**FUNCTIONAL DIFFERENCES BETWEEN
DSP56301 REV. A (MASK F92R)
AND DSP56301 REV. B (MASK F48S) AND
SUBSEQUENT REVISIONS**

26 June 1997

MOTOROLA INC.
6501 William Cannon Dr. West
Austin, Texas 78735

Figure 1 Host Side Registers (PCI Configuration Address Space)

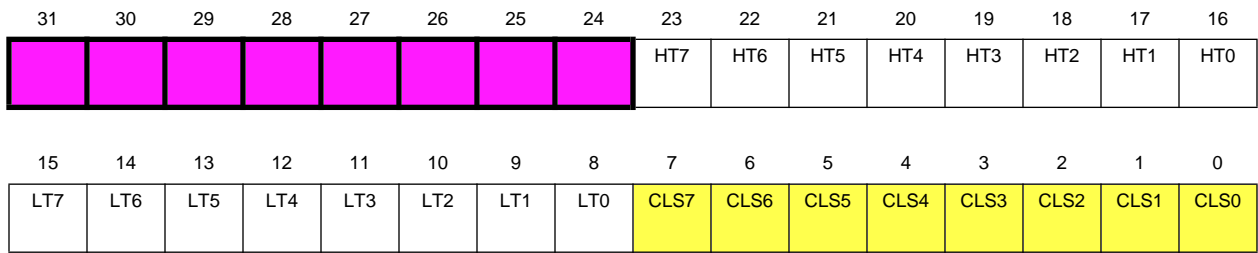
6.4 PCI Configuration Address Space

The following two configuration space registers are added to the HI32:

- Cache Line Size Configuration Register (CCLS)
- Subsystem ID and Subsystem Vendor ID Configuration Register (CSID).

Figure 1 shows the location of the new registers within the PCI configuration address space. A detailed description of each register is provided in the following subsections.

MEMORY MAPS

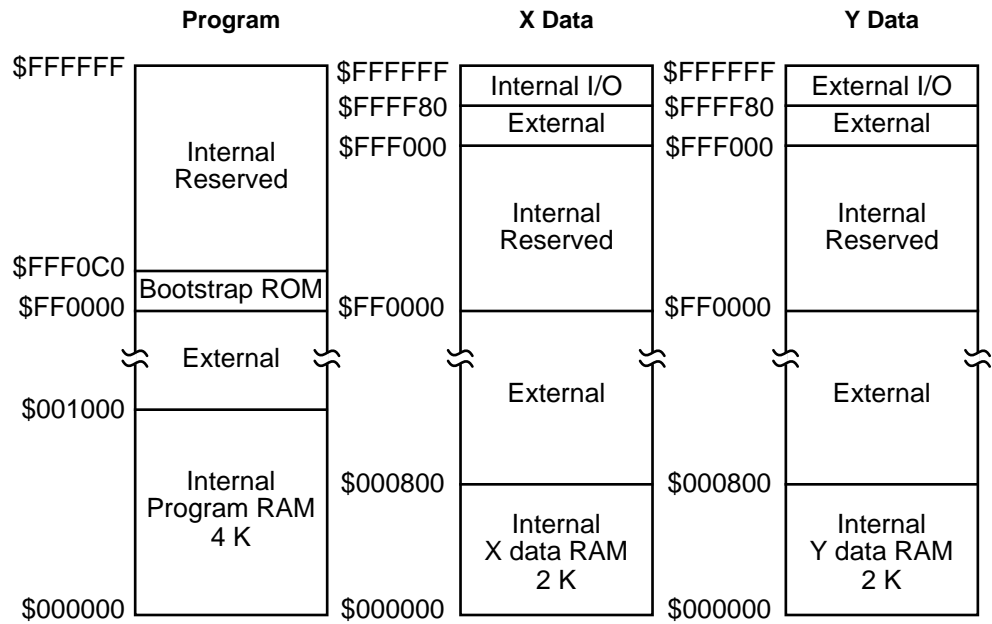
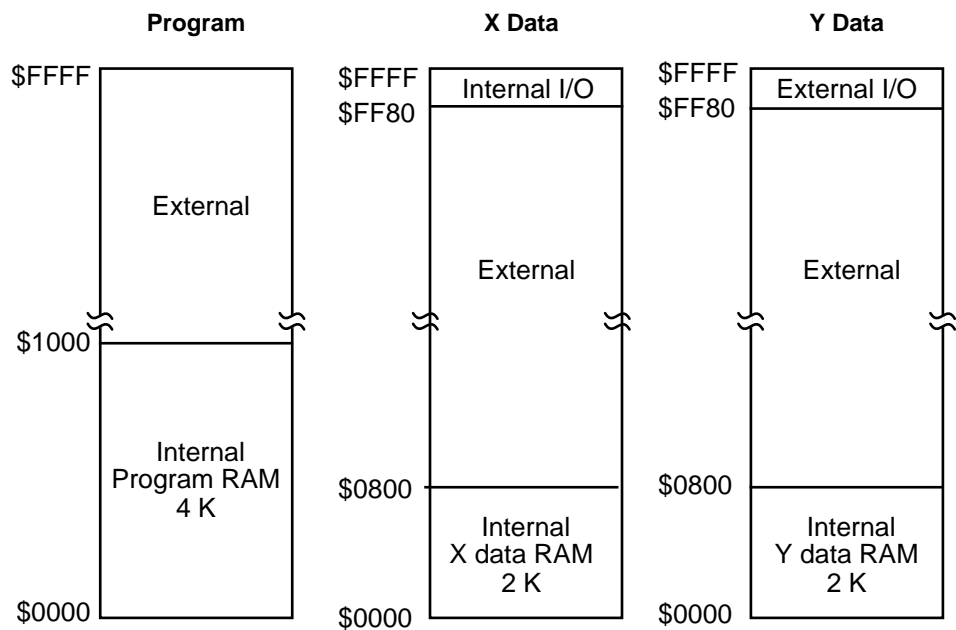
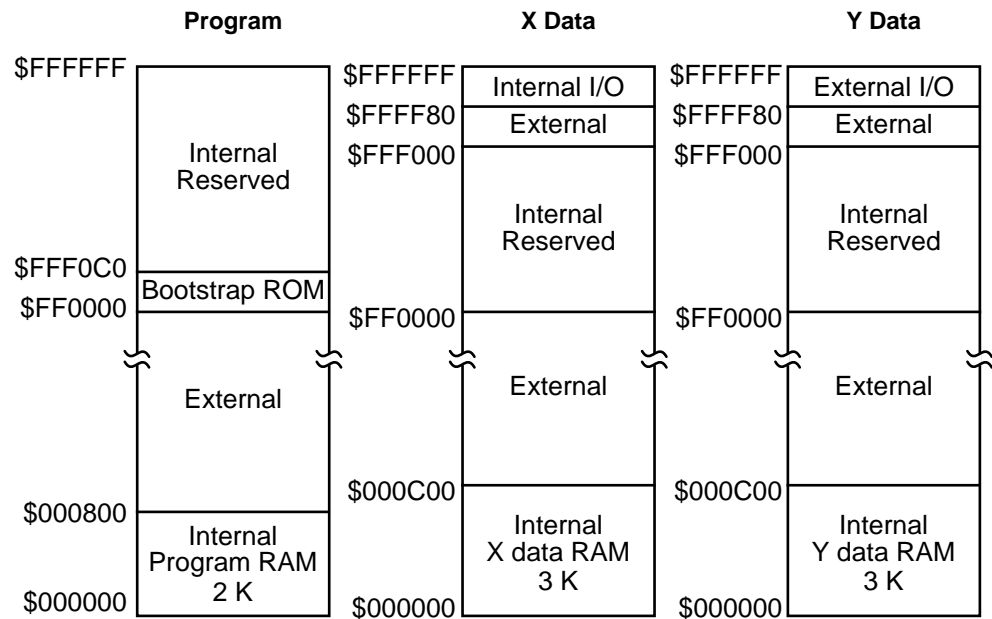
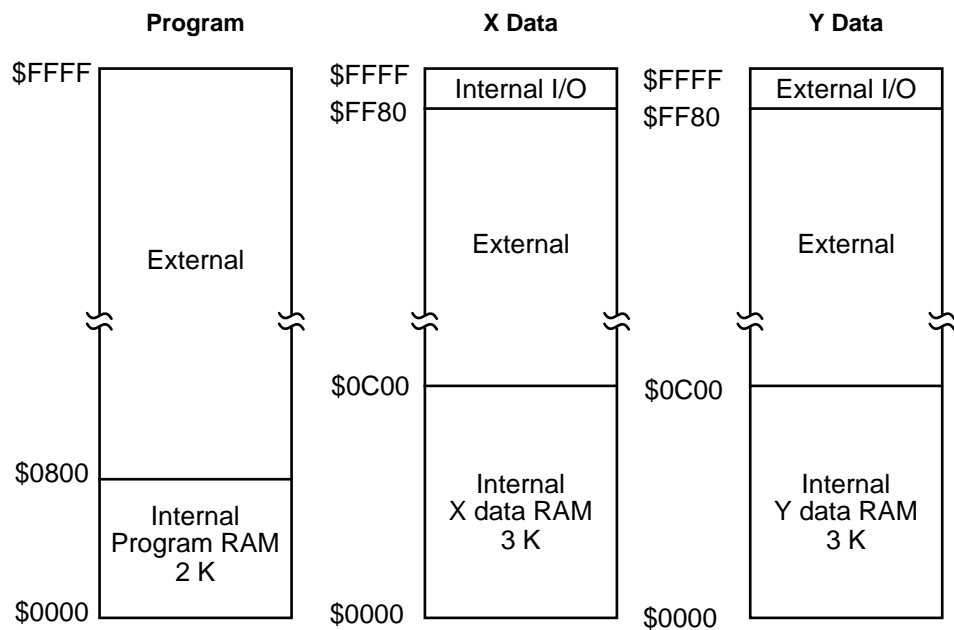
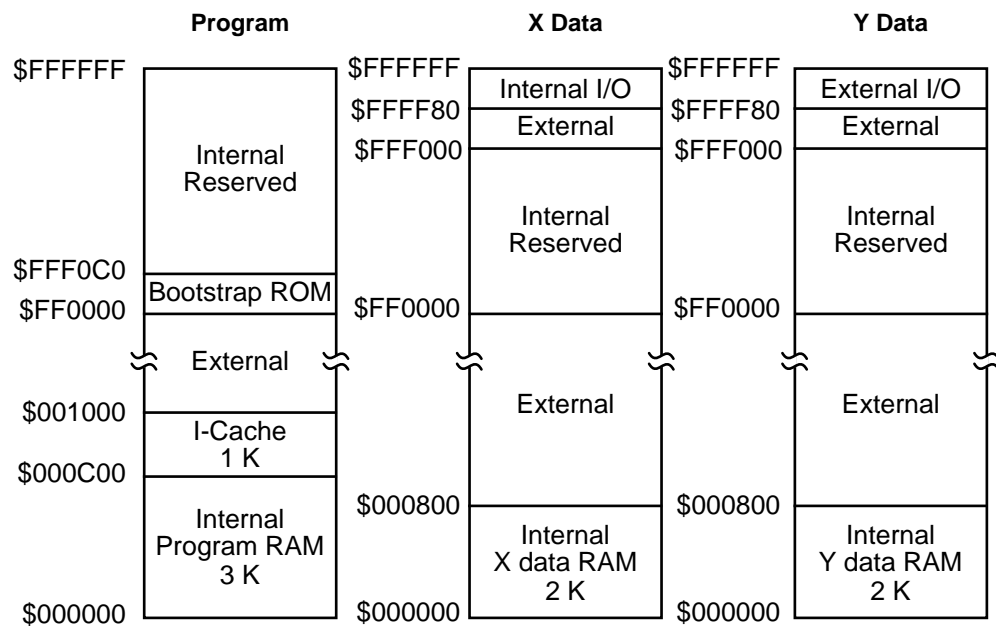
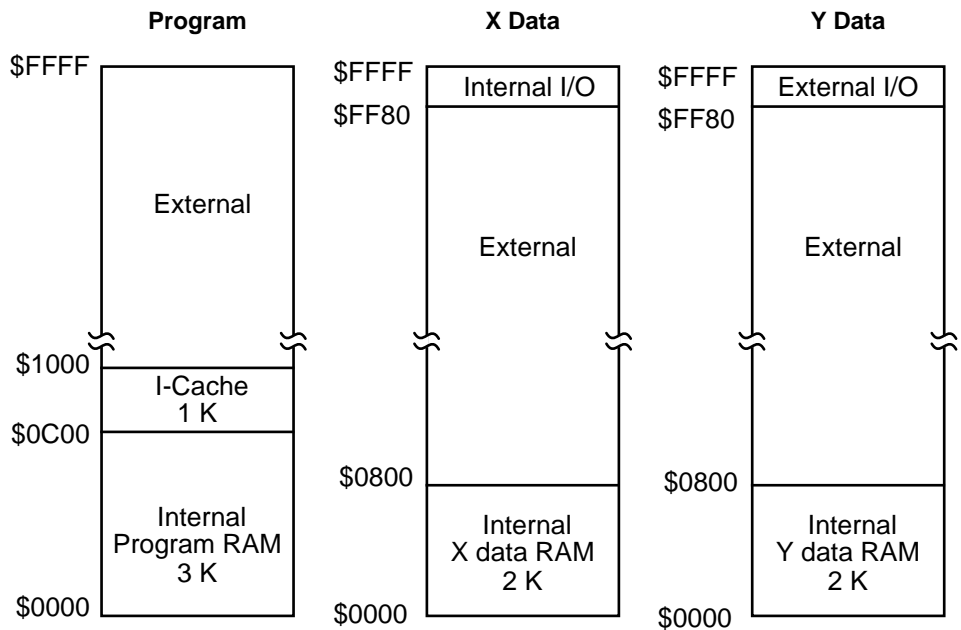
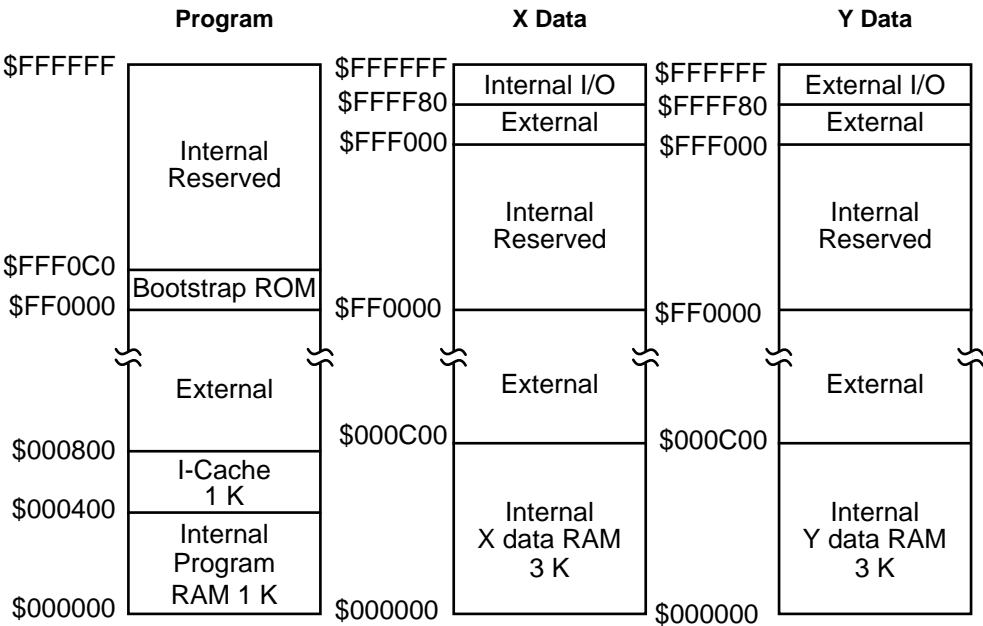
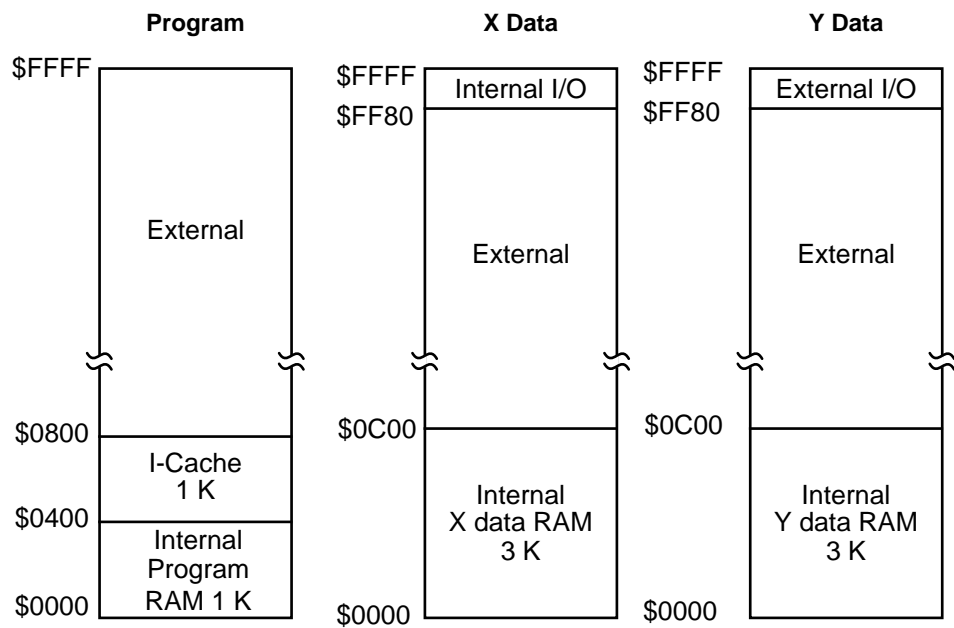
- **Memory Allocation**—A Memory Switch mode was added to provide more flexibility in allocation of memory space by allowing a switch of 2 K of RAM between Program RAM and the X data and Y data RAM spaces. As before, a 1 K program cache space can be allocated within the Program RAM space.

The enhanced functionality adds a Memory Switch (MS) bit in the Operating Mode Register (OMR) that works in conjunction with the previously defined Cache Enable (CE) bit in the Status Register (SR) to reallocate the 8 K of on-chip RAM. **Table 1** describes these bits and their function. **Table 2** provides a summary of the possible memory configurations using the two bits in conjunction.

Detailed memory maps are provide in **Appendix A** on page 15 of this document.

Figure 10 Address Attribute Registers (AAR3-AAR0)

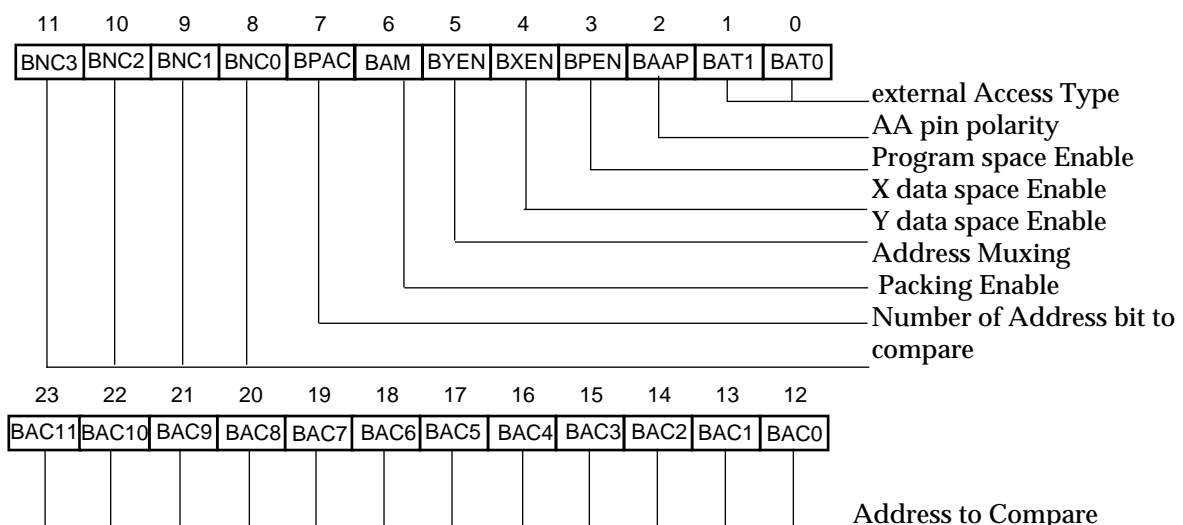
The DSP56301 specification has been changed to add an Address Priority Disable (APD) bit as Bit 14 of the Operating Mode Register (OMR). In the original specification, the priority of the four Address Attribute signals was fixed: AA3 had the highest priority and AA0 had the lowest priority. This priority mechanism did not allow more than one AA to be active at the same time. This prioritization meant the user had to include additional interface hardware to implement the Long Move (MOVE L:) instruction or to use a portion of these signals as additional address lines. The addition of the APD bit allows the user to disable the default priority and perform these functions with no additional hardware. **Appendix B** on page 23 of this document provides a detailed explanation of the new functionality with corrections to **Section 2.5.1** of the *DSP56300 Family Manual* indicated in *italics*.

The **four** control registers (AAR3, AAR2, AAR1, AAR0) are 24 bit read write registers used to control the activity of the AA3-AA0/RAS3-RAS0 pins. An AA/RAS pin is asserted if the address in his appropriate AAR register (BAC bits) matches the external address (the exact number of address bits that are compared is determined by BNC bits) and if the external access is aimed to a space (X Y or P) that is enabled in the appropriate AAR register. All AAR registers are disabled (all the AAR bits are cleared) during hardware reset. The AAR bits are shown in the following figure and described in the following paragraphs.

- Note:
1. A priority mechanism exists among the four AAR control registers in order to resolve selection conflicts. AAR3 has the highest priority and AAR0 has the lowest priority, (e.g. if the external address matches the address and the space that is specified in both AAR1 and AAR2, the external access type will be selected according to the AAR2 register). The priority mechanism allows continuous partition of the external address space.

2. When a selection conflict occurs, i.e. the external address matches the address and the space that is specified in more than one AAR, the assertion of the lower priority AA/RAS pin(s) is programmable. When the APD bit in OMR is cleared (see Chapter 6), only one AA/RAS pin of higher priority will be asserted. When the APD bit is set, the lower priority AA/RAS pin(s) will be asserted in addition to the higher priority AA/RAS pin. AAR of higher priority defines the external memory access type (memory type, wait states etc.) The lower priority AA/RAS pin(s) associated with DRAM memory type (BAT(1:0) = 10) will not be activated. This allows a glueless support of Long Move (move L:) instruction to/from external memory as shown in Figure 11.

Figure 11 Long Move (move L:) instruction support

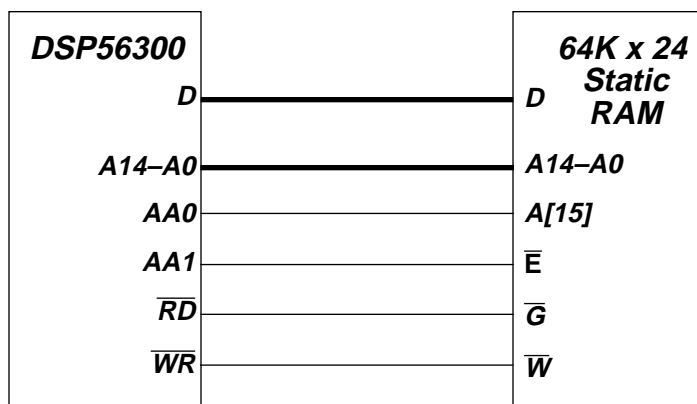
- **Enhanced External Addressing Capability**—An Address Attribute Disable option has been added. This provides a glueless support for the Long Move (MOVE L:) instruction and allows using multiple AA signals as additional address lines.

- Note:
- In this example:
 - X space is mapped to SRAM addresses \$8000-\$FFFF.
 - Y space is mapped to SRAM addresses \$0000-\$7FFF.
 - AAR1 is programmed as SRAM in location X:Y:\$000000-\$007FFF, active low.

- AAR0 is programmed as SRAM in location Y:\$000000-\$007FFF, active low.
 - The instruction "move X,L:\$1000" will generate the following two external accesses:

- X space access to location \$9000. AA0 is high (not asserted).
 - Y space access to location \$1000. AA0 is low (asserted).
 - In both accesses AA1 is asserted and activates the SRAM.
